BOARD OF ADJUSTMENT REFERRAL FORM	
Referred by: JOHN FORBES	Date: 3-4-2026
Department:	
Phone/Email: 214-948-4461/JOHN.FORBES@DALLAS.GOV	
Manager signature: <i>Loree Lewis</i>	
Consulted with: Hakim Mehmood	
<input type="checkbox"/> Applicant	
<input type="checkbox"/> Representative	
<input checked="" type="checkbox"/> Owner	
Name: Hakim Mehmood	
Phone/Email: 214-213-0030/hakimn@gmail.com	
Property Information	
Address: 12450 High Meadow Dr Dallas, Tx 75244	
Lot: 37	
City Block: C/6406	
Zoning Classification: R-10(A)	
Issues that require Board action Addition/garage conversion side setback at 5'6" rather than 6' for R-10(A)	
List the City of Dallas Development Code(s) this project is non-compliant with:	
<b>Check all that apply:</b> <input checked="" type="checkbox"/> Variance <input type="checkbox"/> Special Exception	
<input checked="" type="checkbox"/> Yard setback	
<input type="checkbox"/> Lot Width	
<input type="checkbox"/> Lot Depth

PROJECT:  
MISHA'S CONSTRUCTION LLC  
12450 HIGH MEADOW DRIVE  
DALLAS, TEXAS 75244  
LOT: 57 BLK: C/6406

SITE PLAN  
SCALE: 1" = 20'

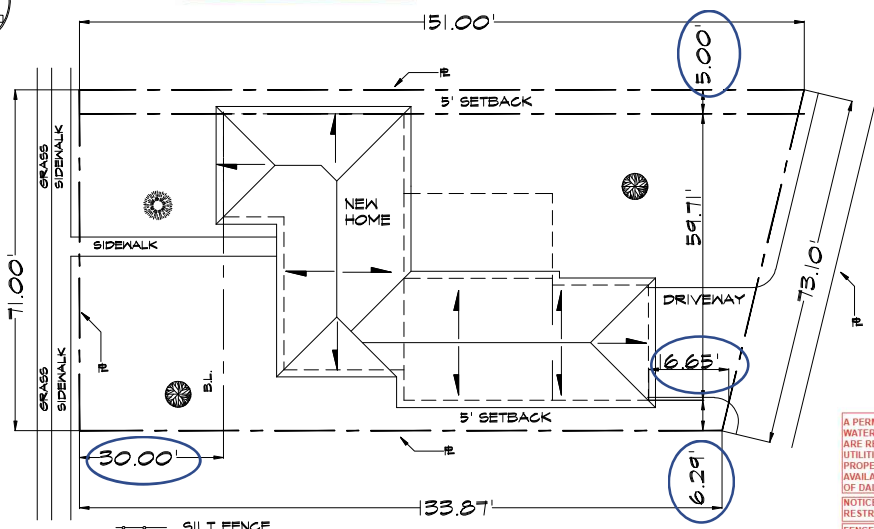
<input type="checkbox"/> Lot coverage	
<input type="checkbox"/> Floor area for accessory structures for single-family uses	
<input type="checkbox"/> Height	
<input type="checkbox"/> Minimum width of sidewalk	
<input type="checkbox"/> Off-street parking	
<input type="checkbox"/> Off-street loading	
<input type="checkbox"/> Landscape regulations	
<input type="checkbox"/> fence height and/or standards	
<input type="checkbox"/> Visibility triangle obstructions	
<input type="checkbox"/> Parking demand	
<input type="checkbox"/> Additional dwelling unit (not for rent) <input type="checkbox"/> Accessory dwelling unit (for rent)	
<input type="checkbox"/> Carport	
<input type="checkbox"/> Non-conforming use or structure	
<input type="checkbox"/> Administrative Official Appeal	
<input type="checkbox"/> Other:	
Description: Existing Garage is at 5' 6" rather than 6'. Site plan supplied and survey later attained contradict actual side setback.
